From: Christa McNeill
Sent: Thursday, July 04, 2013 3:34 PM
To: Bob Marchak
Subject: Re: QUESTION RE PSVs for EXCHANGER - Fw: 3244 Husky Ansell- RFQ for a PSV - Spartan Quote 1993178SQ

E-102
GAS/GAS DEHY. PRE-COOLER

ANSELL GAS PLANT #1 07-27-051-19W5

E-102 & E-110 EXCHANGERS
PIPING & INSTRUMENTATION DIAGRAM

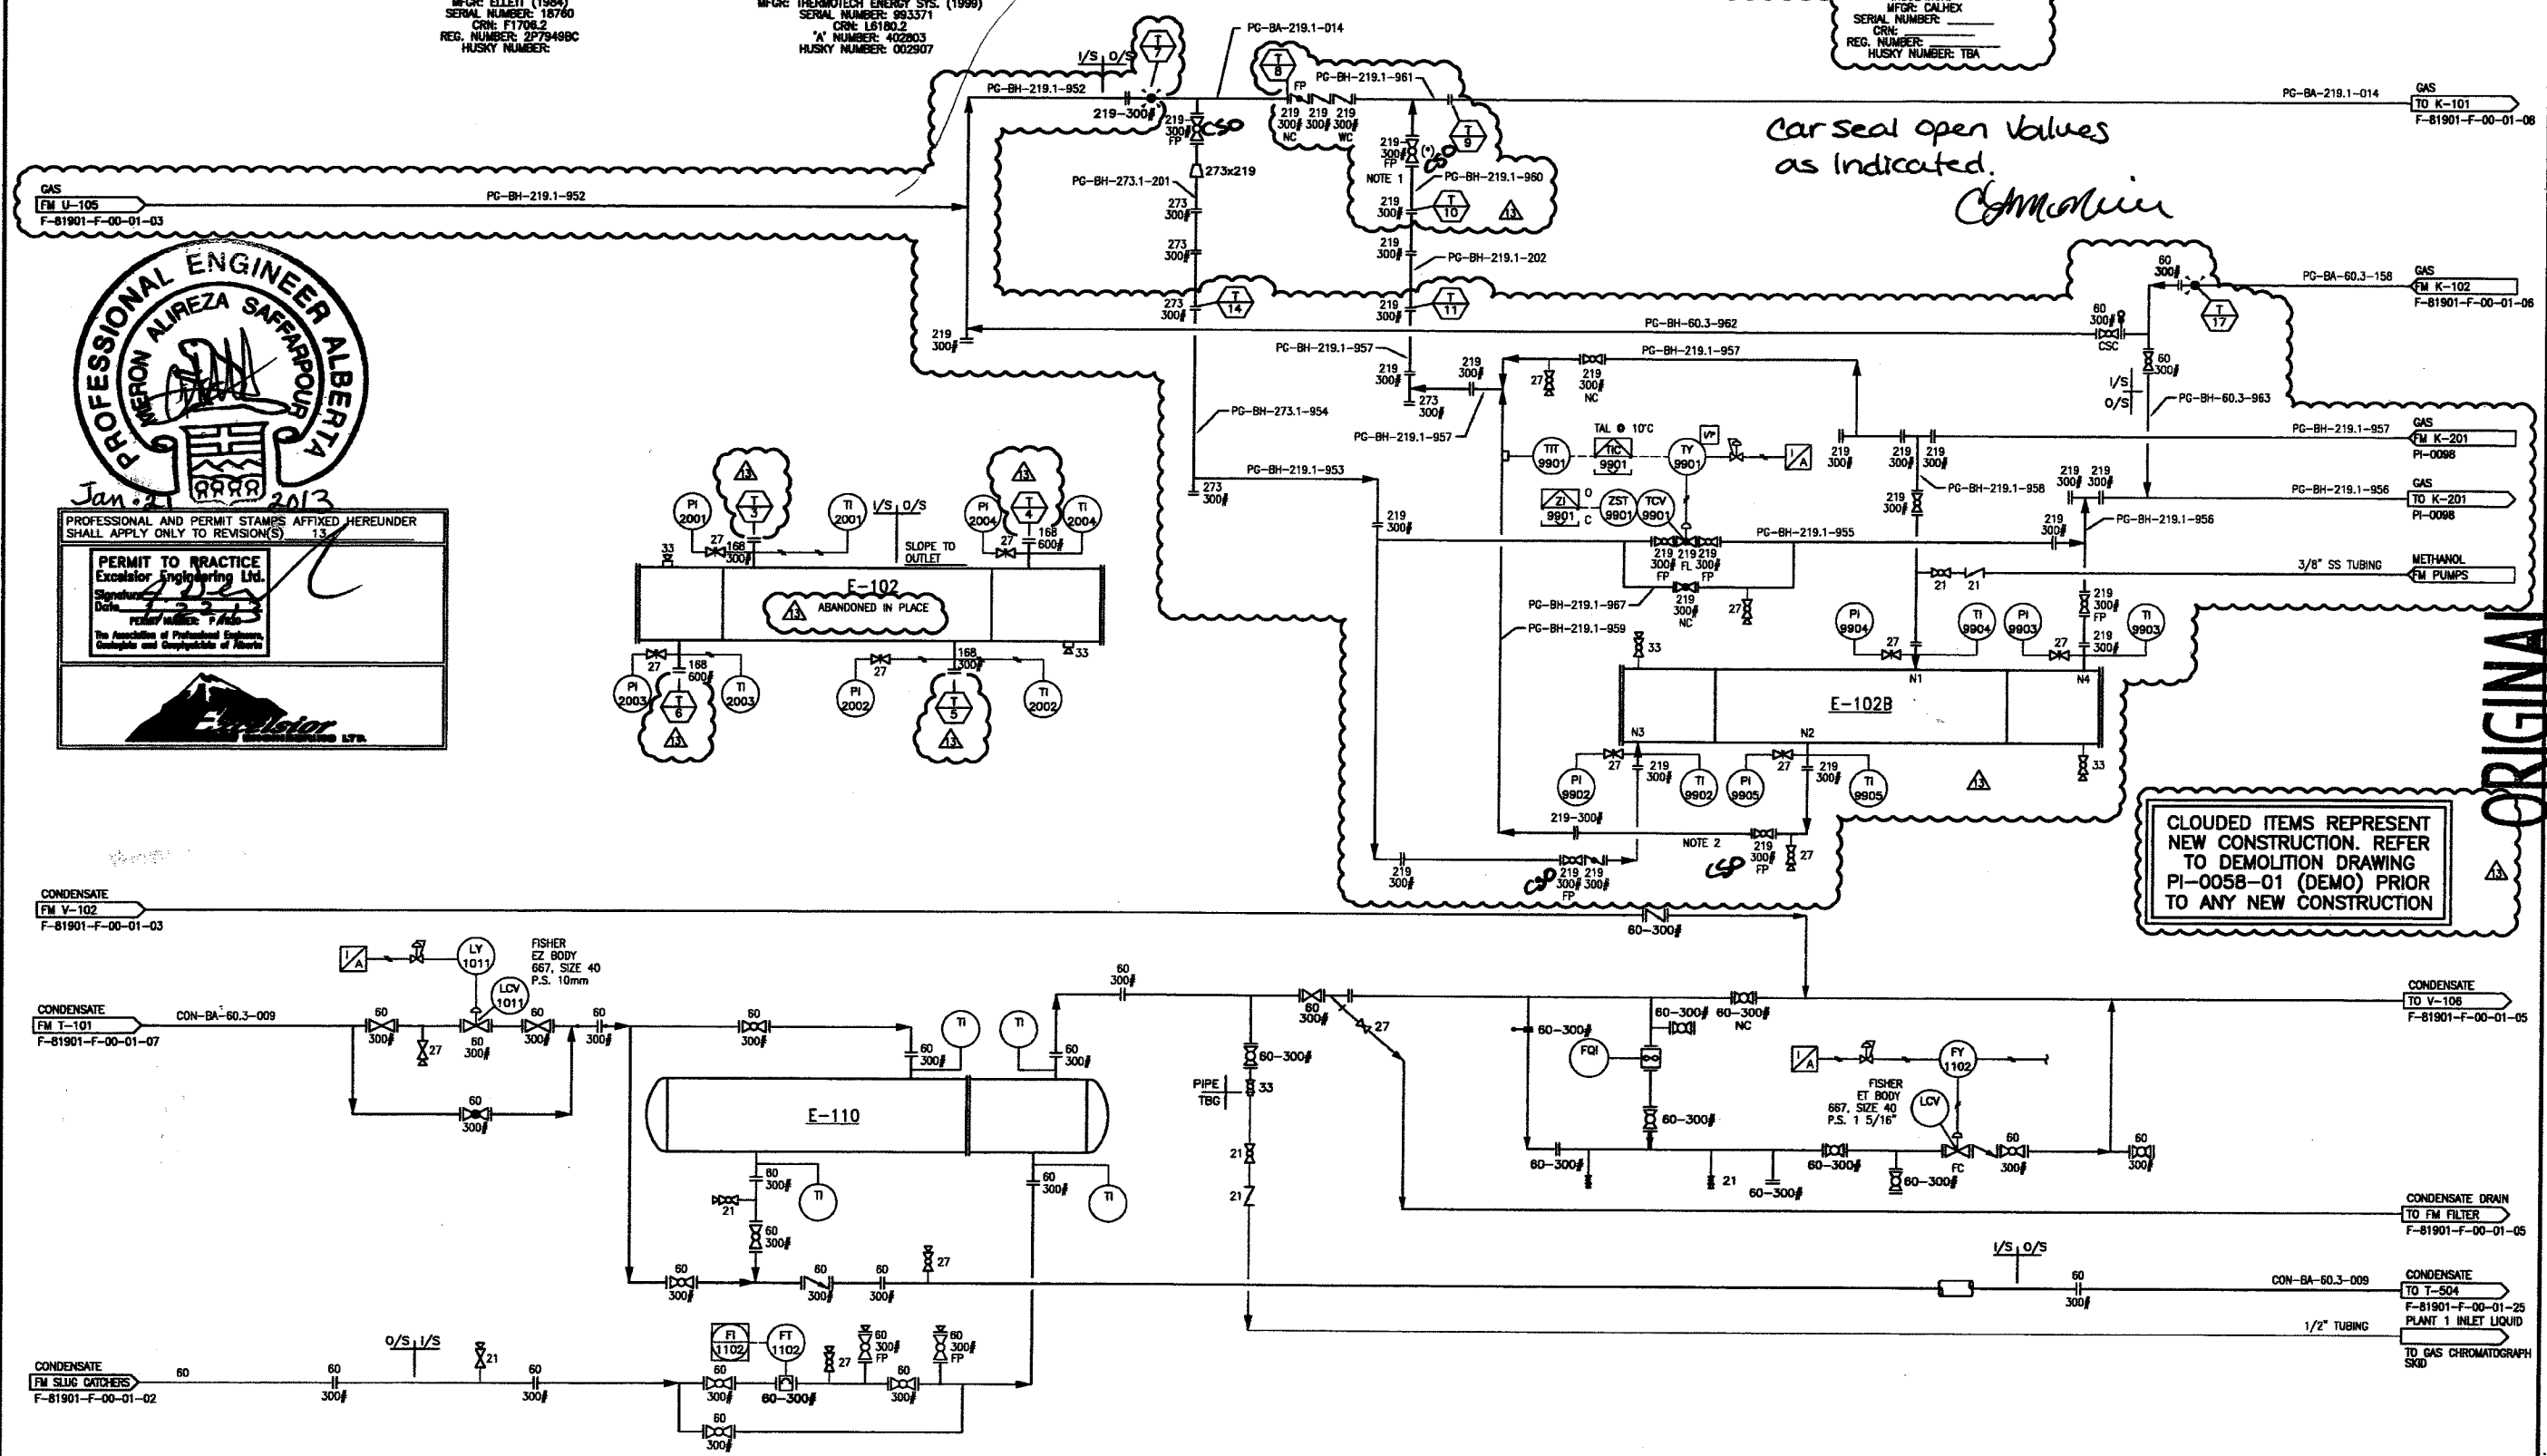
After you brought to our attention during the turnaround the lack of the PSVs on the new exchanger, we decided that we would car seal the required valves for now but proceed with installing PSVs so we won't have to add to the car seal list permanently. The engineering company (see email thread below) is saying that we only need PSVs for the shell side, not the tube side (however, I already had construction build the spools for both). I wanted your opinion on this: do you feel we need PSVs for both shell and tube sides or just for the shell side?

Heat input due to fire will be transferred to the shell side of the exchanger, heating up the fluid in the shell side directly through the wetted surface. If the fluid in the shell side is liquid it boils off and the generated vapor lifts the PSV and if it is gas, the expansion of the gas lifts the PSV. The heat will not be transferred to the tubes directly, it will be transferred via the warmed up fluid inside the shell through conduction/convection. When the fluid inside the shell is a gas, the heat transfer coefficient is very low and if the

fluid in the tube side is also a gas it needs a very prolonged period to expand the fluid in the tube side to lift a PSV. The PSV on the shell side lifts long time before a PSV on the tube side. Also of the heat input to the vessel, most of that will be absorbed by the fluid in the shell side (which will be relieved) and only a portion of that remains to heat up the tubes and tube side fluid. So, in most of the cases, tube side PSV is not required, especially when one side is gas, leave it alone if both sides are gas.

This is new to me so please excuse the question, but why is the fire case only required for the shell side? Is it simply due to the greater volume in the shell side. I thought the tubes were only rated for 2758 kPA (at least that's what I think the pressure rating is, I don't have the drawings in front of me). From our inspector's comments during the turnaround I thought both sides required a PSV.

Thanks Bob, we'll go with both, especially since we already built the spools.

Hey Christa, from my knowledge of the codes and from my experience, both shell and tube sides require "overpressure protection". The tubeside, unless it states "overpressure by design" on the manufacturers data report, will need a PSV.
